Access Compliance Report

Public Rights-of-Way

Intersection ID: 53235	Main Street: EVERGREEN_DR	Cross Street: DOLLY_MADISON_RD	Location: SE
ADA ID: 35C340C483F1	Ramp Type: BlendTrans1	Initial Pass/Fail: Fail	Overall Compliance: No
		Severity Score: 10

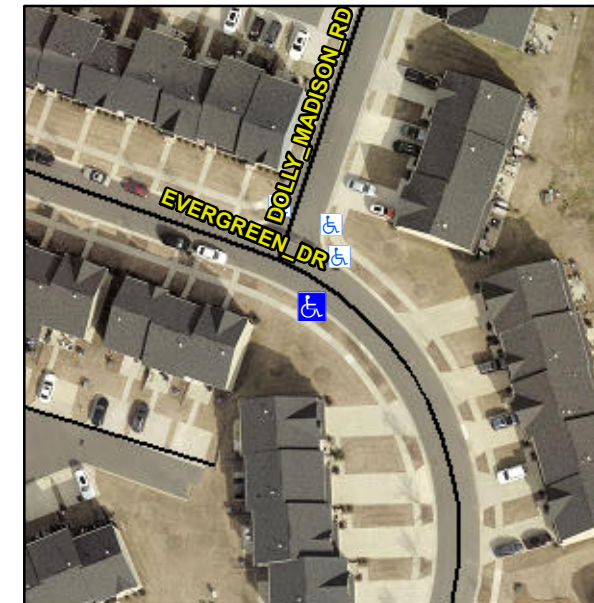
Not Found, R304.5.1

Compliance	Description	Data	Compliance	Description	Data
N/A	Ramp Length (in)	73.5	Yes	BlendTrans Slope (%)	3.1
No	Ramp Width (in)	47.0	Yes	BlendTrans XSlope (%)	3.9
N/A	Flare Type LT	N/A	N/A	Flare Type RT	N/A
N/A	Flare Slope LT (%)	N/A	N/A	Flare Slope RT (%)	N/A
N/A	Flare Traversable LT?	N/A	N/A	Flare Traversable RT?	N/A
N/A	Landing Length (in)	N/A	N/A	DWS Provided?	N/A
N/A	Landing Width (in)	N/A	N/A	DWS Contrast?	N/A
N/A	Landing Slope (%)	N/A	N/A	DWS Length (in)	N/A
N/A	Landing X Slope (%)	N/A	N/A	DWS Full Width?	N/A
N/A	Landing Curb? (Y/N)	N/A	N/A	DWS Offset (in)	N/A
N/A	Shared Landing?	N/A			
N/A	Gutter Ponding?	N/A	N/A	Gutter Slope (%)	N/A
N/A	Gutter Lip Ht (in)	N/A	N/A	Gutter X Slope (%)	N/A
N/A	Painted X Walk1?	No	N/A	Painted X Walk2?	N/A
	X Walk 1 Direction	To N		X Walk 2 Direction	N/A
	X Walk 1 Width (in)	N/A		X Walk 2 Width (in)	N/A
	X Walk 1 Slope (%)	0.8		X Walk 2 Slope (%)	N/A
	X Walk 1 X Slope (%)	5.4		X Walk 2 X Slope (%)	N/A

N/A	Ramp inside XWalk1?	N/A	N/A	Ramp inside XWalk2?	N/A
	Road Slope (%)	5.4		Clear Space?	N/A
	Road X Slope (%)	0.8	N/A	Clear Space to XWalk (in)	N/A
N/A	Any Obstructions?	N/A	N/A	Storm Grate/Utility Hazard?	N/A
	Obstruction Type			Storm Grate/Utility Type	
		N/A			N/A
			Yes	Surface Condition? (G/P)	Good
			No	Curb Slope (%)	16.2

Remove & Replace Curb Ramp With Two New Directional Ramps or Equivalent.
